Preliminary Arboricultural Assessment

Riverlands Development
56 Prescott Parade, Milperra
Community Facility
DA-4/2020
LEC No: 2020/267229
20/08/2024

Figure 6. Retention values, TPZs, SRZs and Encroachments for eight assessed trees. Riverlands Community Facility - Site Plan & Sediment Control Plan, prepared by Mirvac Design (Job No: MB-10243, Rev: B, drawn: 19/06/2024). Annotated by Temporal Tree Management Pty Ltd. (13/08/2024)

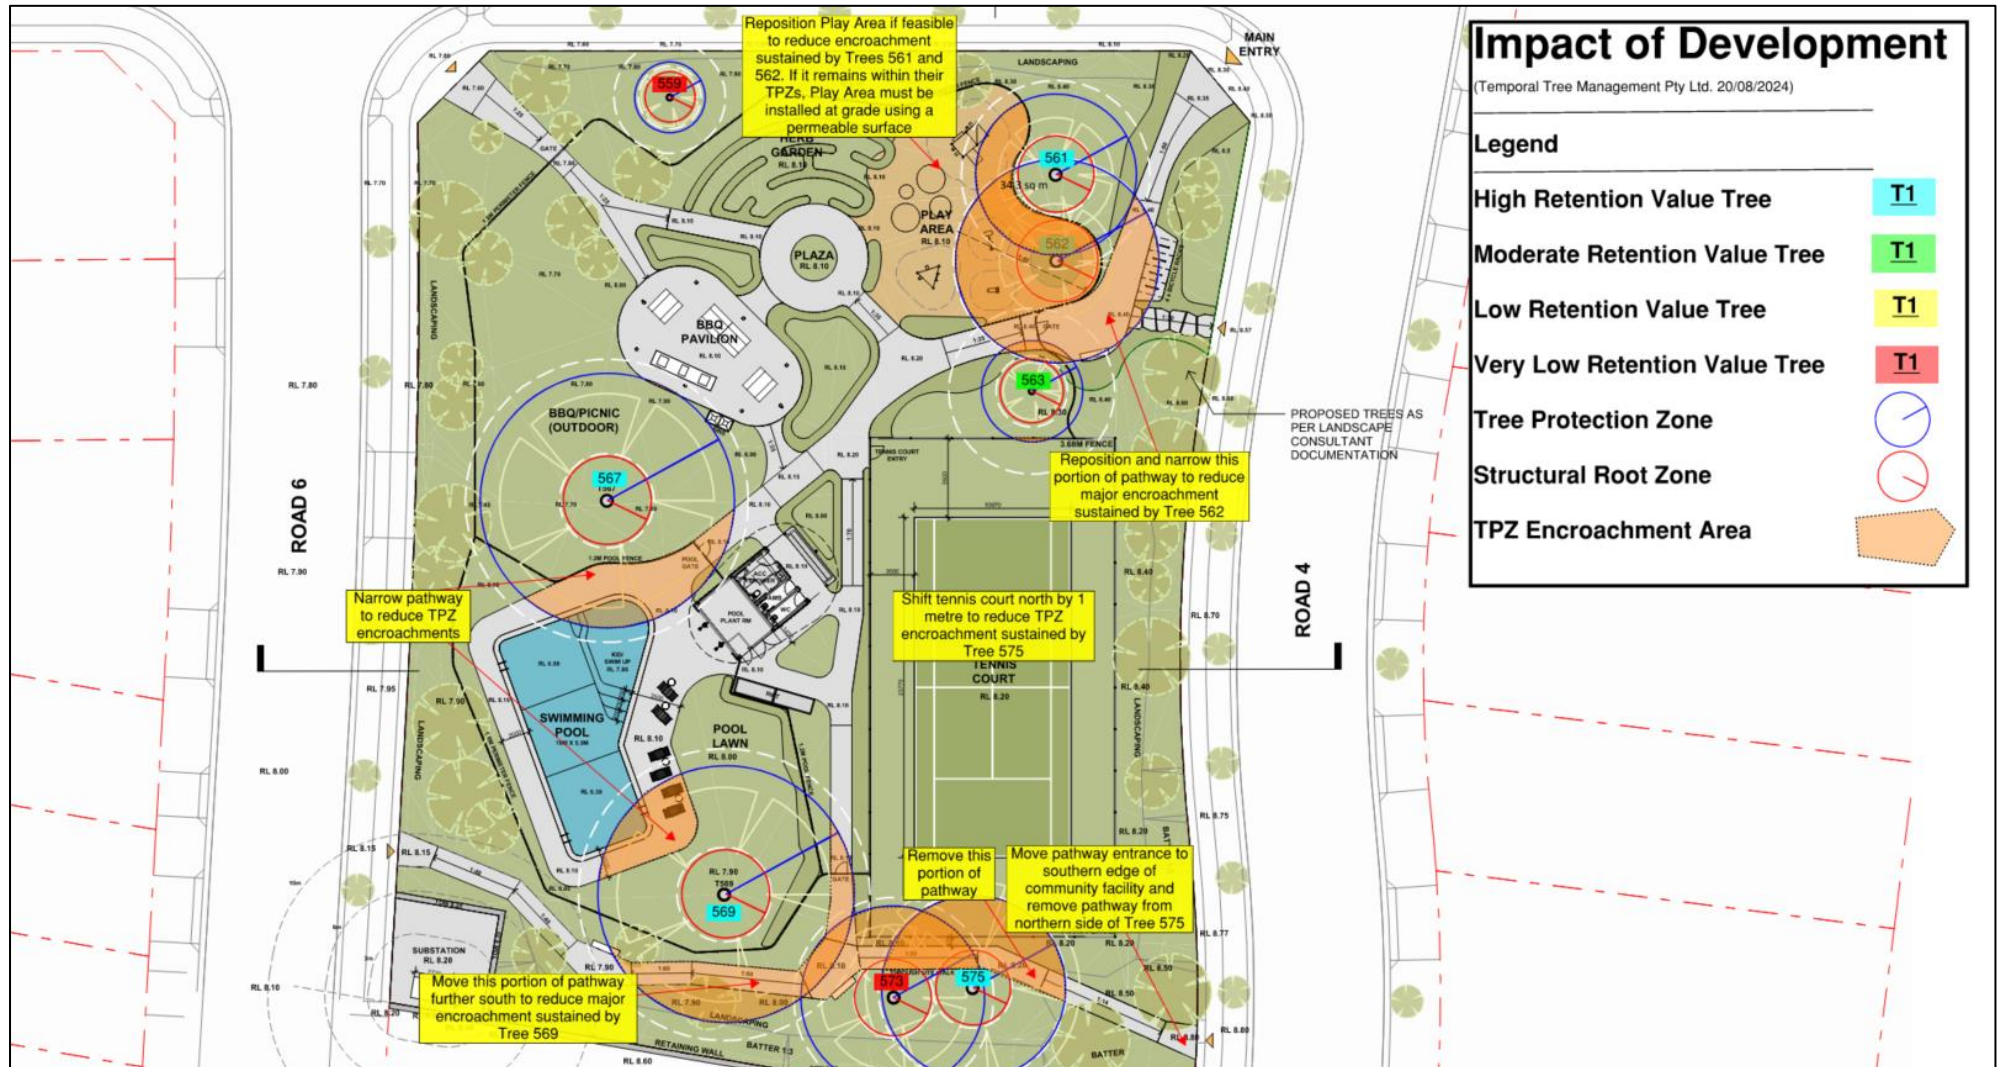
- Trees 561, 562, 563, 567, 569 and 575 remain in good or fair condition and must be retained and protected as per Condition 124 of the *DA*.
- Tree 563 will sustain a minor TPZ encroachment under the proposed design that will have an acceptable minor impact on its viability. This tree can be suitably retained without any modifications to the proposed design.

- Trees 561, 562, 567, 569 and 575 will sustain major encroachments of 20% or more that are likely to negatively impact their viability within the landscape. Amendments to the proposed design are required to mitigate the impact of these major TPZ encroachments.

- The Play Area should be repositioned to reduce the encroachment within the TPZs of Trees 561 and 562. If it remains within the TPZs of these two trees, the Play area surface must be permeable and installed at grade or with minimal excavation (max depth 50mm).

- The widest portions of the pathways on the northern and south-eastern sides of the proposed pool should be narrowed to reduce to encroachment within the TPZs of Trees 567 and 569.

- The shared pathways within the TPZs of Trees 562, 569, 575 should be repositioned if feasible to reduce the TPZ encroachments.
- The pathway entrance within the south-eastern corner of the Community Facility should be moved to the southern edge to reduce the major TPZ encroachment sustained by Tree 575.

- Pathways should be installed at grade or require minimal excavation (max depth 150mm) for installation.
- If feasible, the proposed tennis court should be moved 1 metre in the northern direction to minimise the encroachment sustained by Tree 575. Tree 563, which is a smaller tree that was observed to be in good health, will sustain an acceptable increase in the encroachment within the southern portion of its TPZ under this proposed modification.

Tree	SRZ Encroachment	Encroachment (%)	Impact	Mitigation	Proposed Management
559	No	0	N/A	Tree will not be directly impacted by proposed development.	Remove. Small dead tree must be removed and replaced.
561	Yes	34	Severe	Tree will sustain major encroachment within western portion of TPZ during installation of Play Area. Level of encroachment is likely to impact viability within landscape.	Retain. Reposition Play Area to reduce TPZ encroachment. Ensure Play Area surface is permeable and is installed at grade or requires minimal excavation (max depth 50mm) for installation. Install tree protection measures compliant with Section 4 of AS4970 (2009).
562	Yes	79	Severe	Tree will sustain major encroachment within western portion of TPZ during installation of Play Area and within southern portion of TPZ during installation of pathway. Level of encroachment is likely to impact viability within landscape.	Retain. Reposition Play Area and narrow pathway to reduce TPZ encroachment. Ensure Play Area surface is permeable. Ensure play area and pathway are installed at grade or require minimal excavation (max depth 50mm) for installation. Install tree protection measures compliant with Section 4 of AS4970 (2009).

563	No	8	Low	Tree with smaller DBH and TPZ than initially assessed. Will sustain a minor encroachment within the southern portion of its TPZ. Tree will suitably tolerate this minor encroachment without any design mitigation. Trees smaller size, good health and Moderate retention value render it suitable for a greater encroachment if required.	Retain. Install tree protection measures compliant with Section 4 of AS4970 (2009). Tennis court should be moved closer to this tree to reduce the encroachment sustained by Tree 575.

Tree	SRZ Encroachment	Encroachment (%)	Impact	Mitigation	Proposed Management
567	No	20	High	Tree with smaller DBH and TPZ than initially assessed. Will sustain a major encroachment within the southern portion of its TPZ during installation of pool and surrounding pathway.	Retain. Narrow pathway on northern side of pool to reduce TPZ encroachment. If feasible, ensure installation of pathway surrounding pool requires minimal excavation (max depth 150mm) for installation. Install tree protection measures compliant with Section 4 of AS4970 (2009).
569	No	34	Severe	Tree with smaller DBH and TPZ than initially assessed. Will sustain a major encroachment within the TPZ during installation of pool and pathways.	Retain. Narrow pathway on south-eastern side of pool to reduce TPZ encroachment. If feasible, ensure installation of pathway surrounding pool requires minimal excavation (max depth 150mm) for installation. Reposition footpath on southern and eastern sides of stem to minimise encroachment. Ensure pathways are installed at grade or require minimal excavation (max depth 50mm) for installation. Install tree protection measures compliant with Section 4 of AS4970 (2009).

573	Yes	36	Severe	Tree will sustain major encroachment within the northern portion of its TPZ during installation of proposed pathway.	Remove. Larger dead tree must be removed and replaced.
575	Yes	41	Severe	Tree will sustain major encroachment within the northern portion of its TPZ during excavation for the proposed tennis court and pathway.	Retain. Reposition pathway entrance to southern edge of communal facility to reduce TPZ encroachment. Entrance and pathway may be positioned to pass through Tree 573, which will be removed. Tennis court should be moved in the northern direction to minimise the encroachment sustained by Tree 575. Install tree protection measures compliant with Section 4 of AS4970 (2009).
